TRANSMITTAL MEMO

Item #: P20-227

The applicant is submitting a request for a Development Option Plan for the properties located at 315, 317, 325, 327 Batch Plant Rd, legally known as 22-41-16-32-1-00-008.04.

**315 - 327 BATCH PLANT ROAD JACKSON WY
 PERMIT AMENDMENT
 12-10-20**

UPPER UNITS

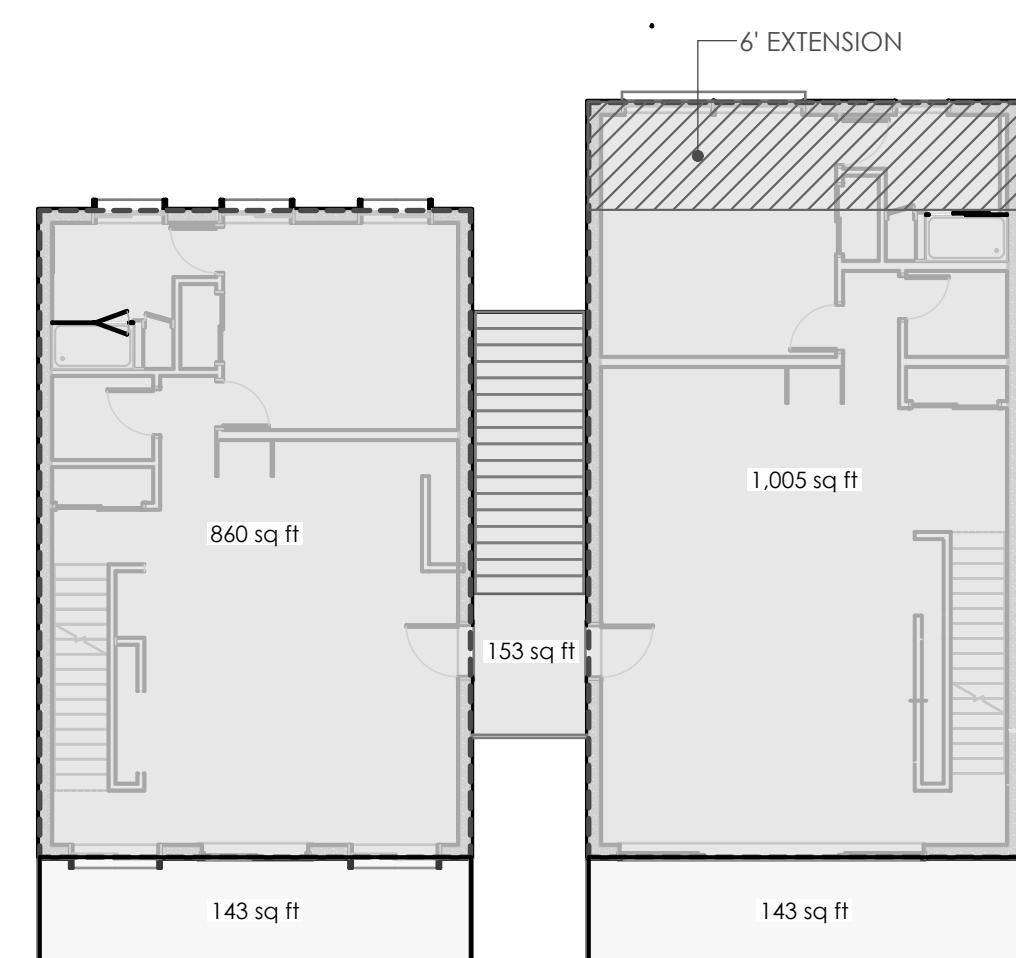
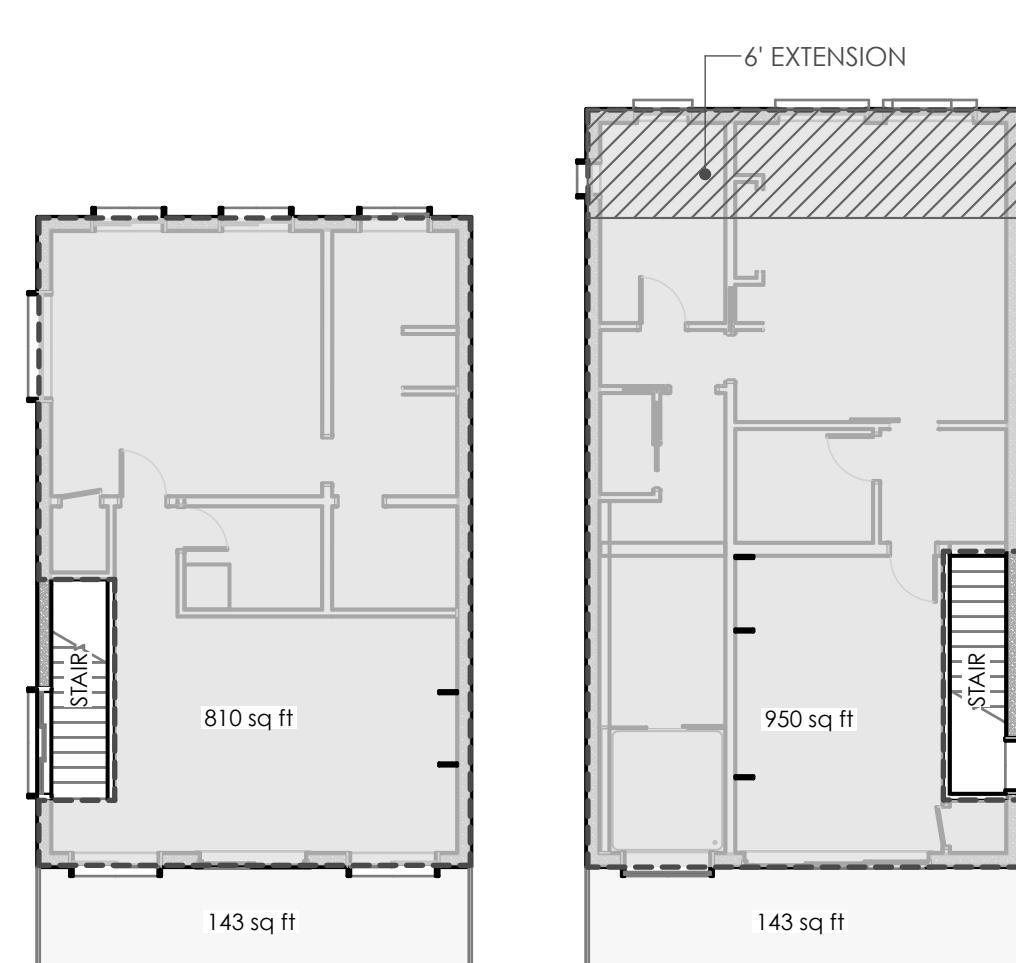
The depth of unit 502 was increased by 6' resulting in an increase of 288 SF habitable area and 144 SF of non-habitable. This increase results in a total FAR SF of 22,325 SF which stays below the original allowable FAR of 0.52 or 22,560 SF. See page A002 & A003 for SF breakdowns and diagrams.
